CLIMATE  
ACTION  
RESERVE

## **SUMMARY OF COMMENTS & RESPONSES DRAFT RICE CULTIVATION PROJECT PROTOCOL VERSION 1.0**

10 sets of comments were received during the public comment period for the Climate Action Reserve (Reserve) draft Rice Cultivation Project Protocol Version 1.0. Staff from the Reserve summarize and provide responses to these comments below.

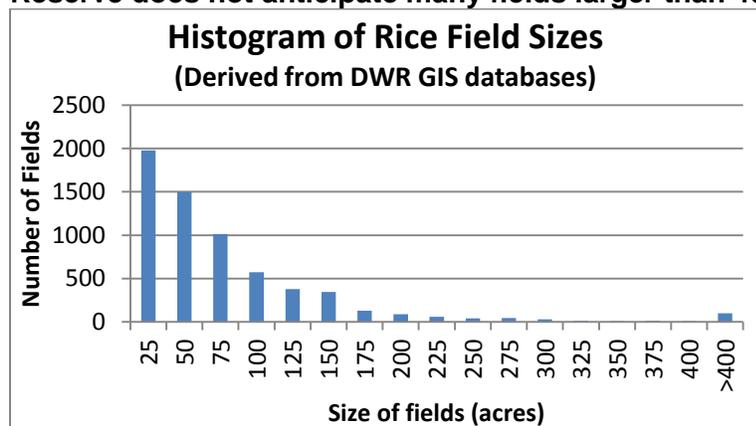
However, a project aggregator may find it a challenge to enroll more fields and adhere to the maximum acreage of a single field requirement. The aggregator would be unable to enroll two more fields of 1,100 acres each in her project aggregate. The number of fields would increase to 12 and the aggregate size would grow to 12,000 acres which would put the project in a new category that has a 7.5% maximum single field acreage ceiling. Unfortunately, the largest single field would be 10% of the total aggregate size and above the specified ceiling in Table 2.2. It is

unclear why such an aggregate is disallowed. It has a greater sample size and the largest single field declines so the statistical certainty of the modeling results should increase.

The Climate Trust recommends the Reserve set a percentage range or establish a hard acreage ceiling range to ensure project aggregates are not artificially constrained from growing. **(TCT)**

**RESPONSE:** The Reserve agrees that the maximum acreage percentage, as outlined in Table 2.2 of the public comment version of the RCPP, could impede the growth of an aggregate, particularly when the aggregate moves from one percentage threshold to another. As such, the Reserve has updated Table 2.2 in the final RCPP (see below), to reflect percentage maximum thresholds based on the number of fields enrolled in an aggregate, as opposed to aggregate acreage, with guidelines similar to those the Reserve uses for aggregated Forestry projects.
